# 2714 DUNSMUIR, CUMBERLAND

## HERITAGE ALTERATION PERMIT AMENDMENT

2022.09.06

Client:  
Postmark Group

# 3TH FLOOR PLAN

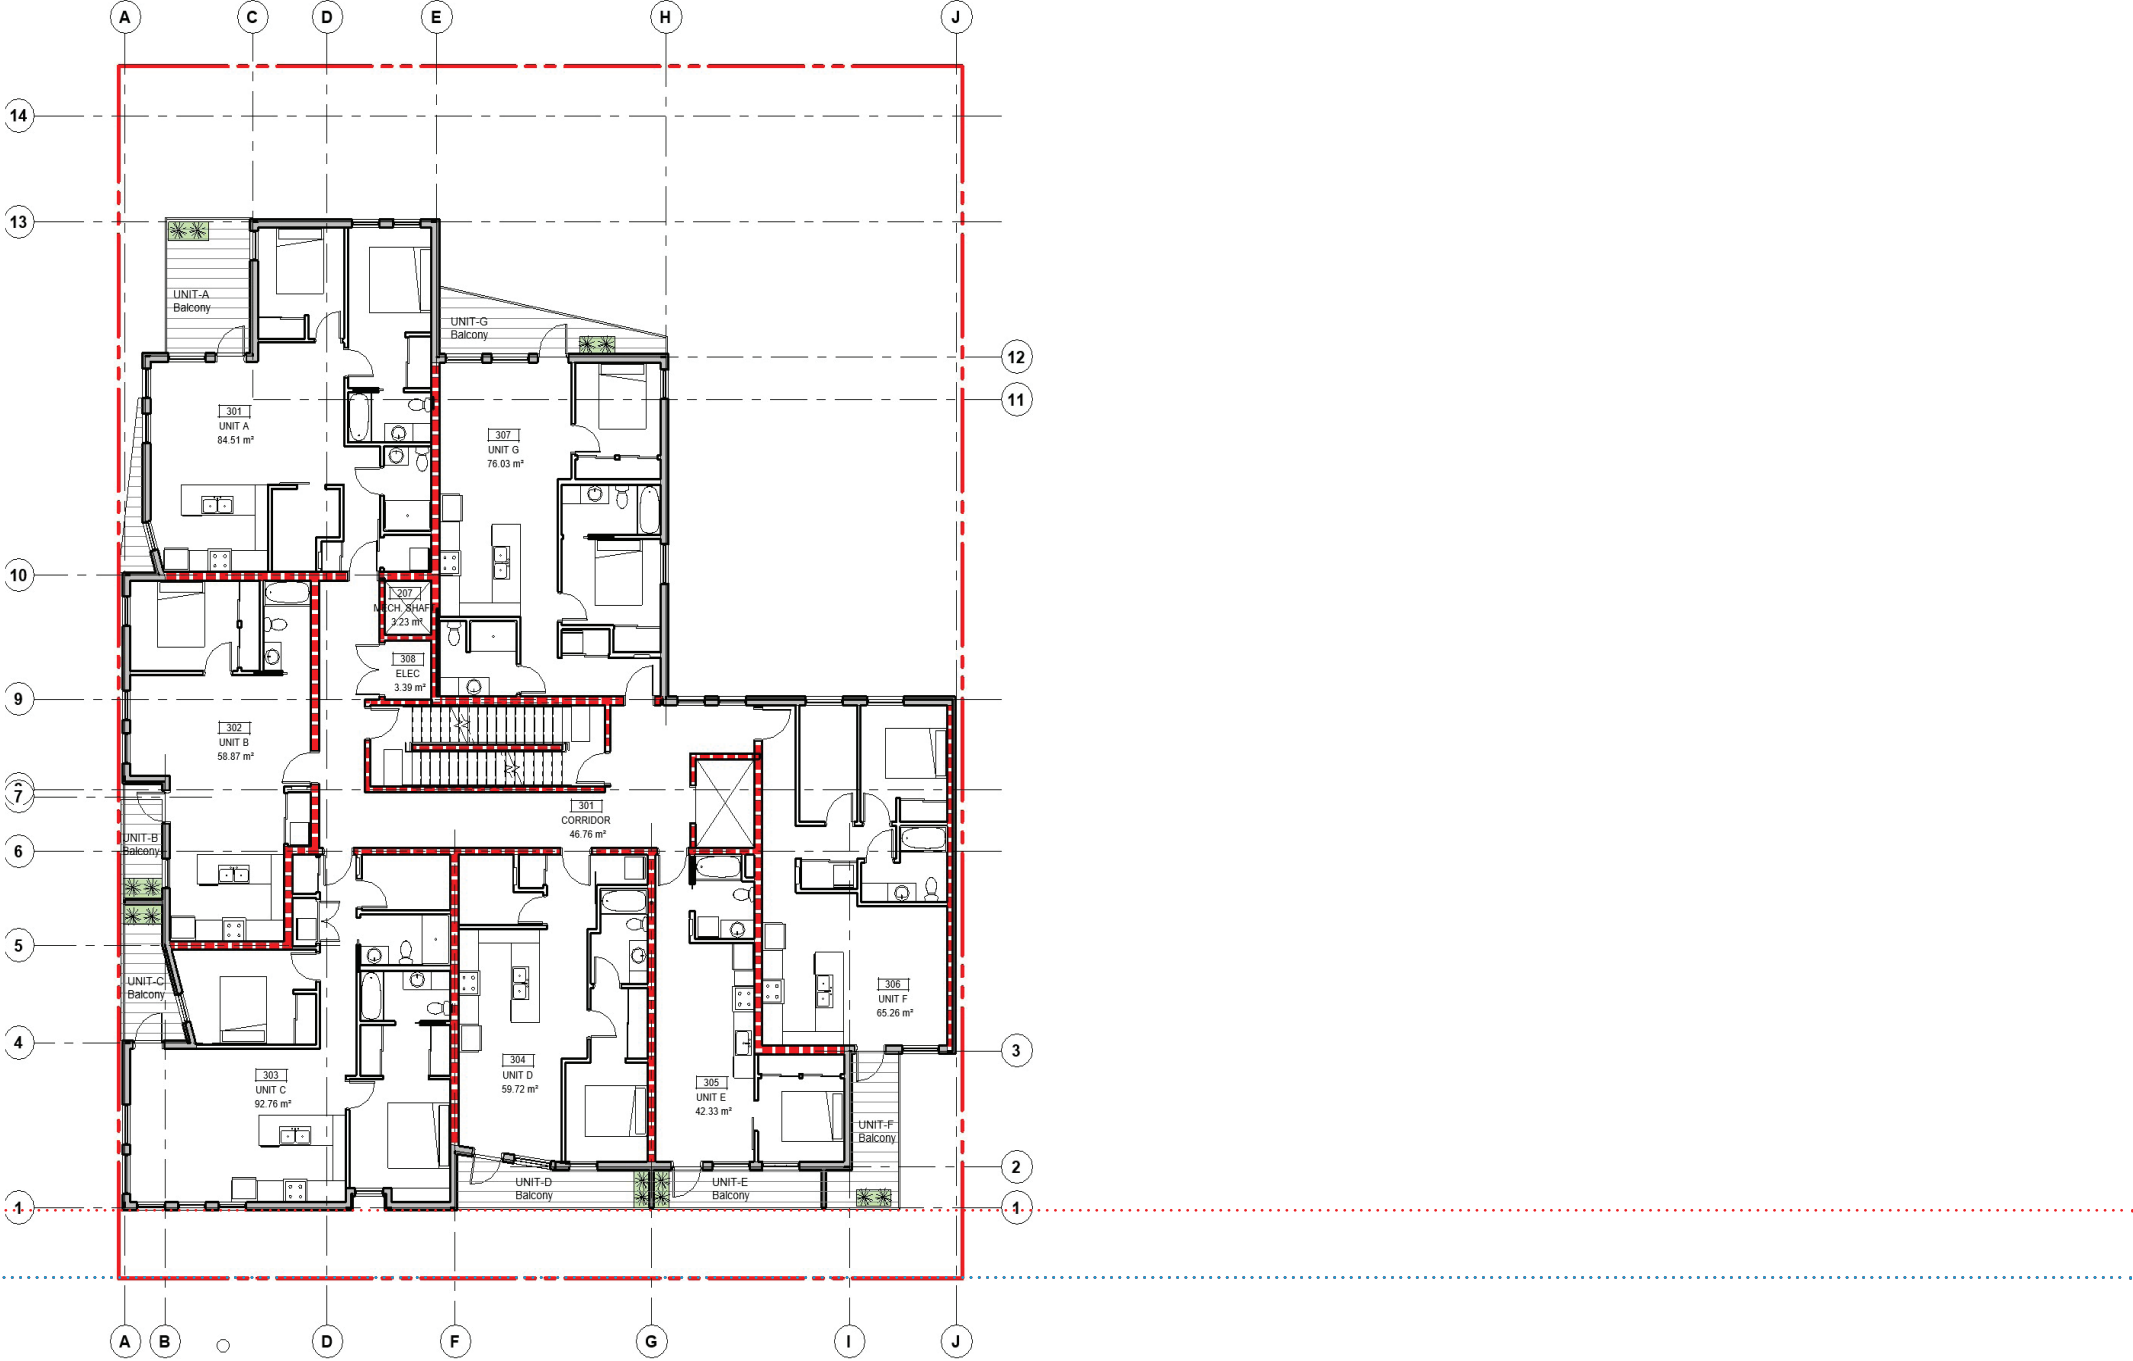
FOOT PRINT WAS BEEN INCREASED  
2 EXTRA UNITS PER FLOOR

# 4TH FLOOR PLAN

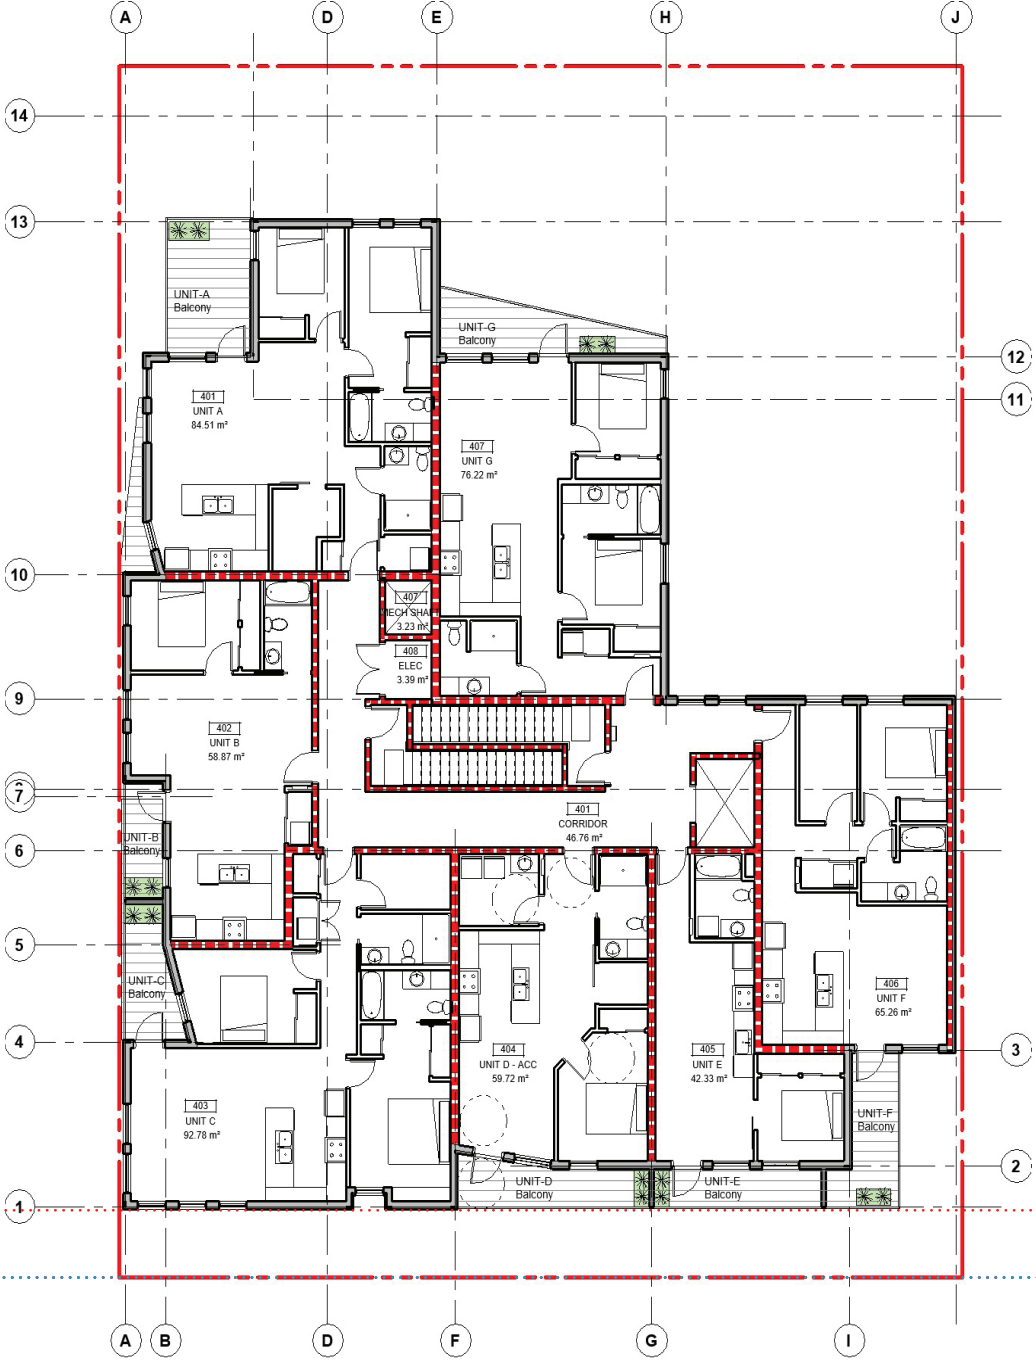
FOOT PRINT WAS BEEN INCREASED  
2 EXTRA UNITS PER FLOOR

# ROOF PLAN

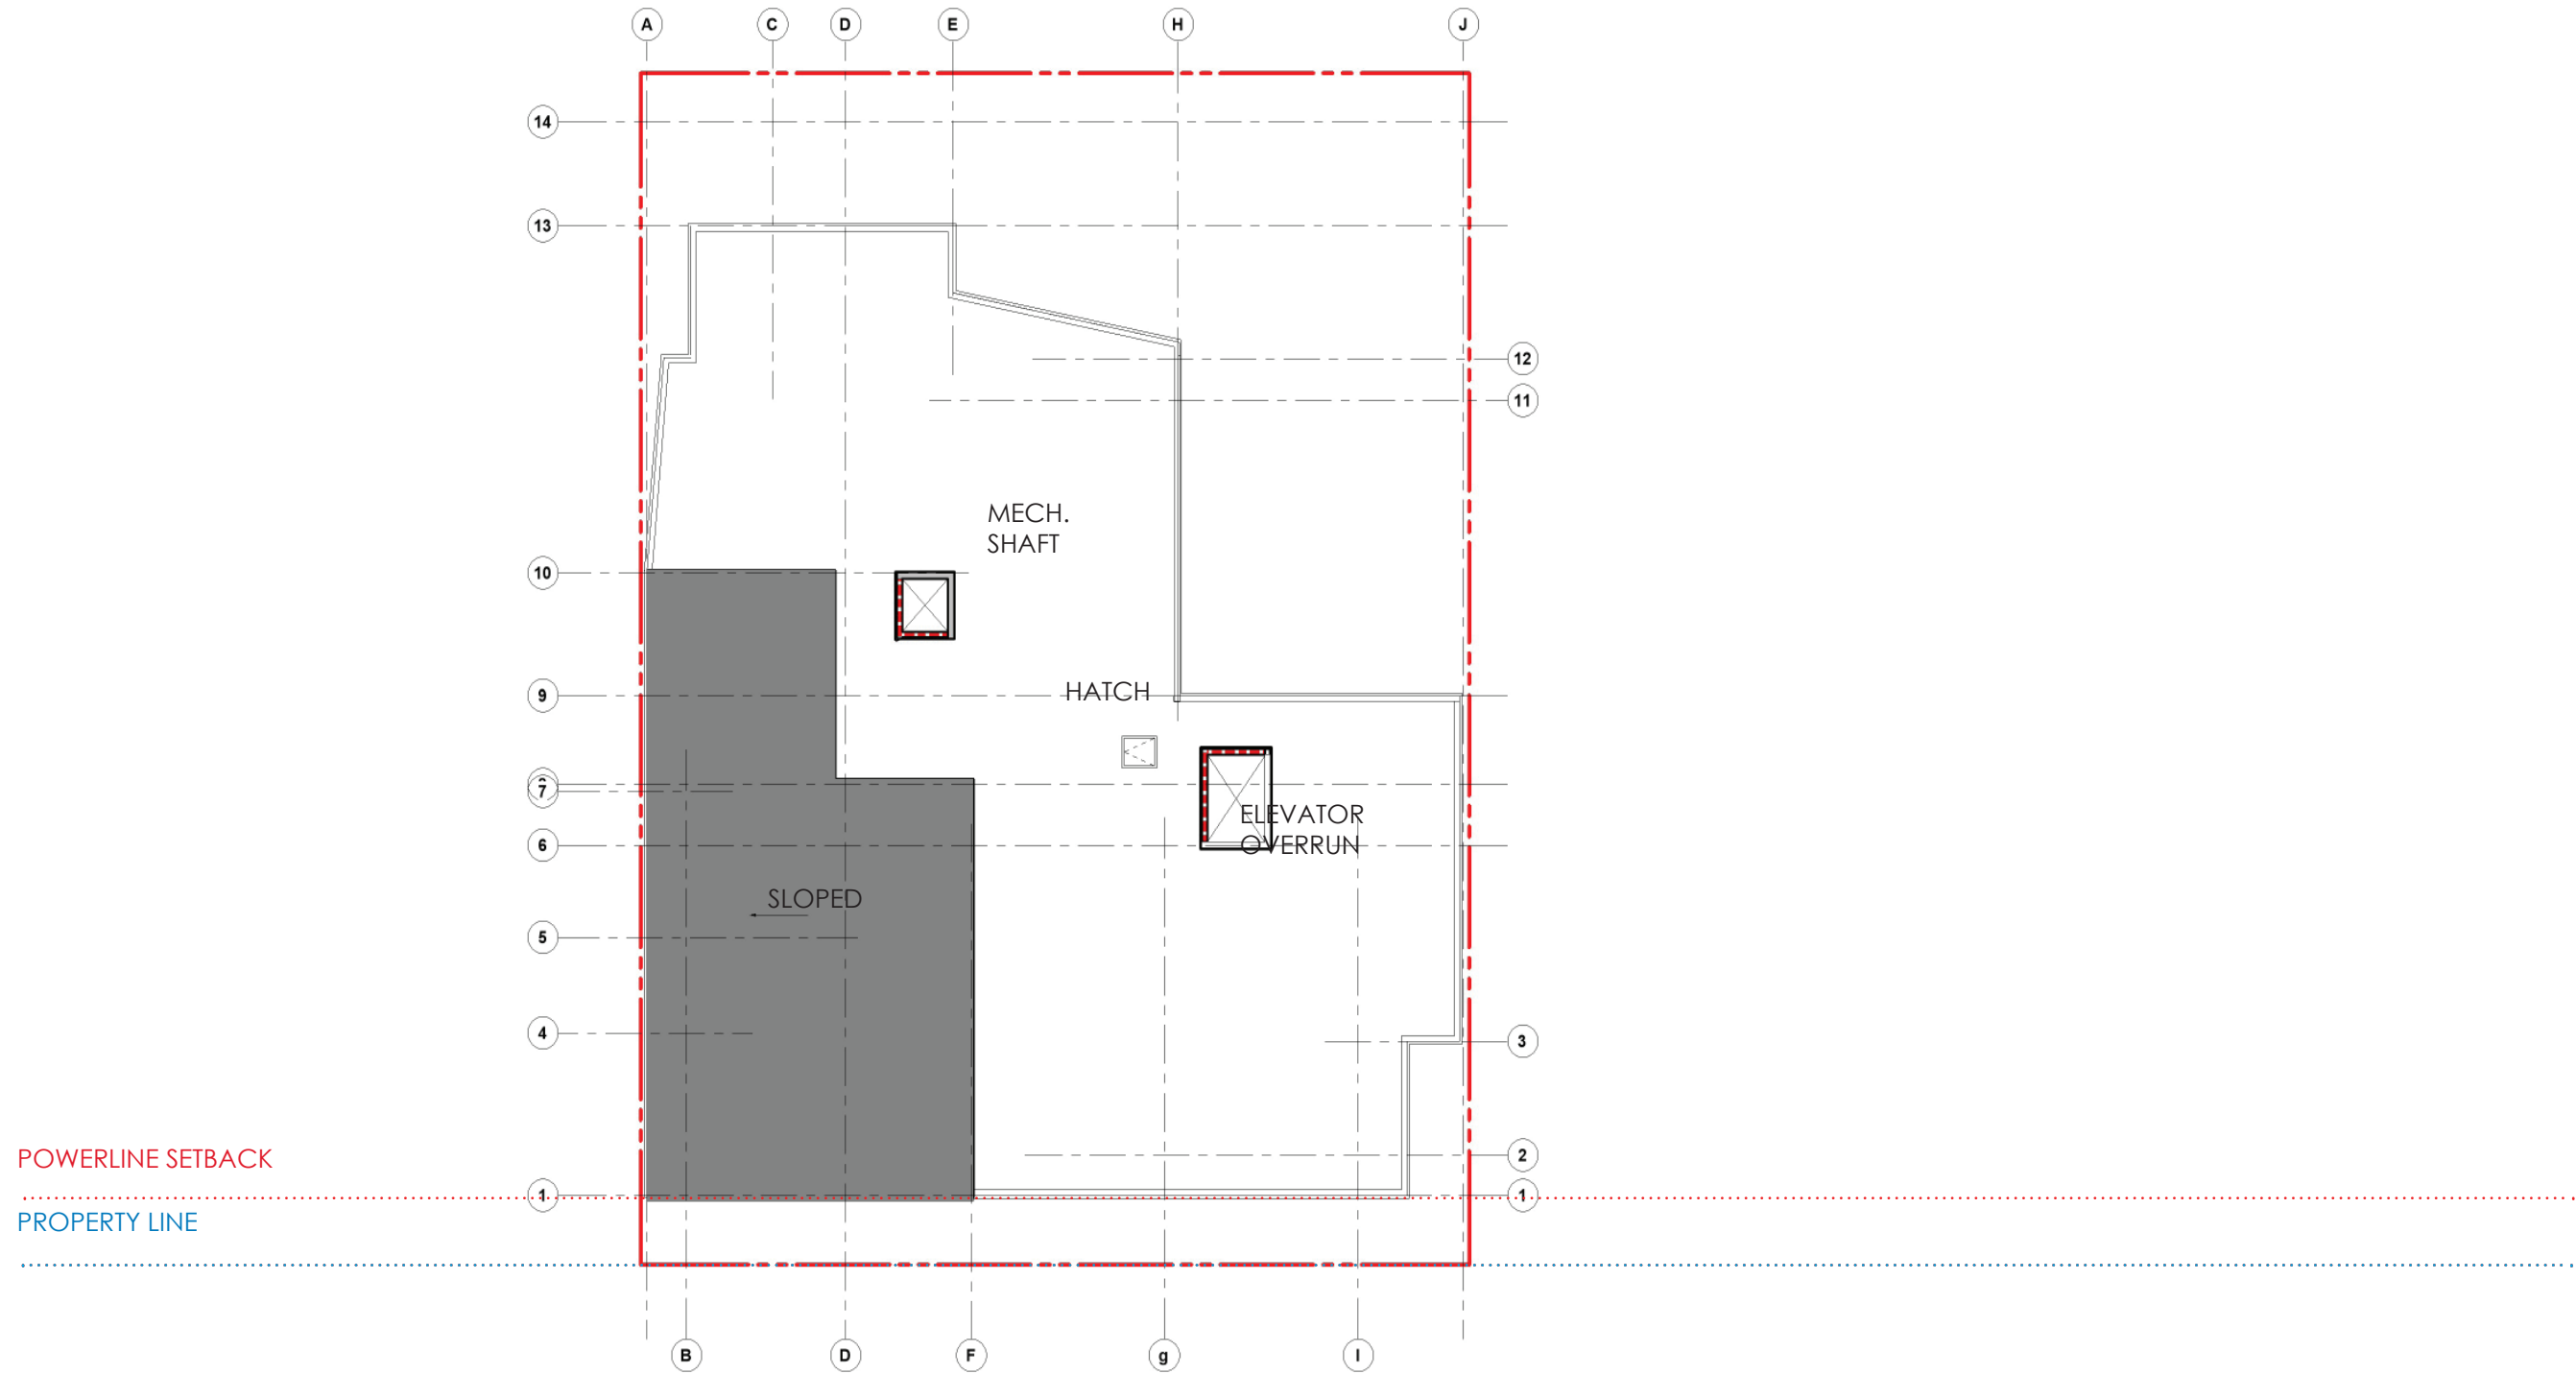
FLOOR AREA AS BEEN REDUCED TO ONLY THE SLOPED ROOF, MECHANICAL SHAFT AND THE ELEVATOR OVERRUN. ROOF IS ACCESSIBLE BY LADDER WITH ROOF HATCH

# ELEVATION CLADDING

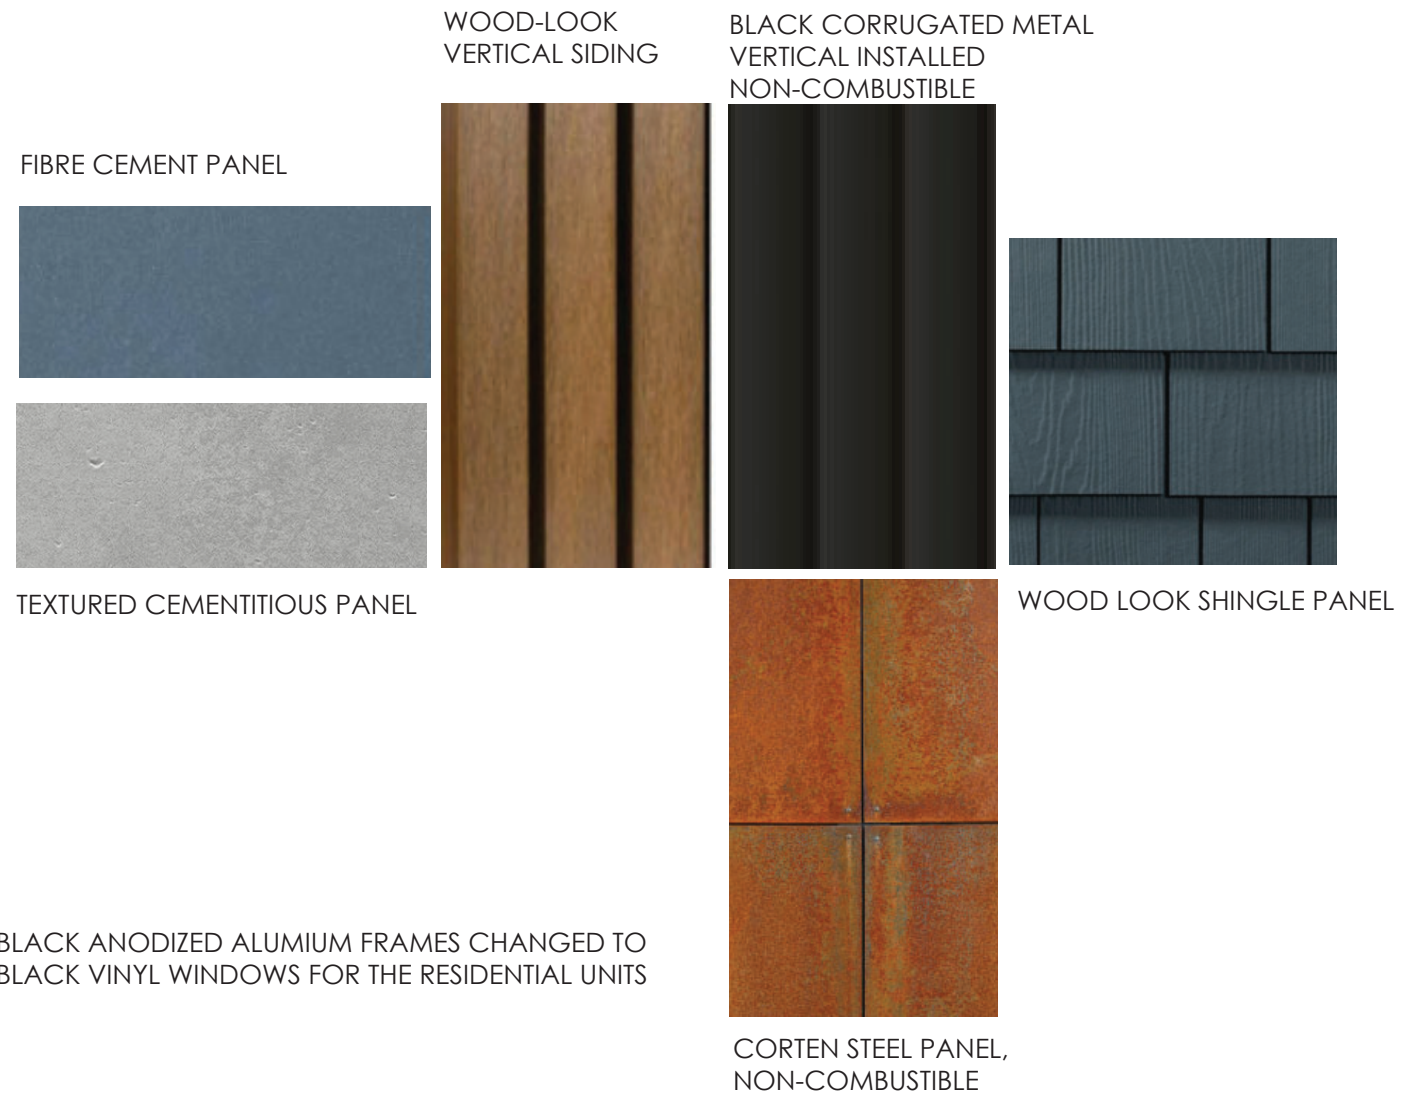
8. CLADDING MATERIAL CHANGED TO MEET THE FUNCTIONAL AND CODE REQUIREMENTS:
  - A. VINYL CHARRED SIDING PANEL CHANGED TO A NON-COMBUSTIBLE BLACK CORRUGATED METAL CLADDING

- B. LAMINATED TIMBER SIDING IN THE COURTYARD CHANGED TO CORTEN STEEL METAL PANEL
  - C. THE MATERIALS OF THE CORNER RESIDENTIAL VOLUME HAVE BEEN CHANGED TO BLUE SHINGLES. PREVIOUSLY APPROVED WITH A COMBINATION OF THE WOOD LOOK HORIZONTAL SIDING AND SHINGLES. WE FEEL LIKE HAVING 1 MATERIAL (SHINGLES) PROVIDES BETTER HARMONY AND SIMPLIFIES THE FAÇADE.
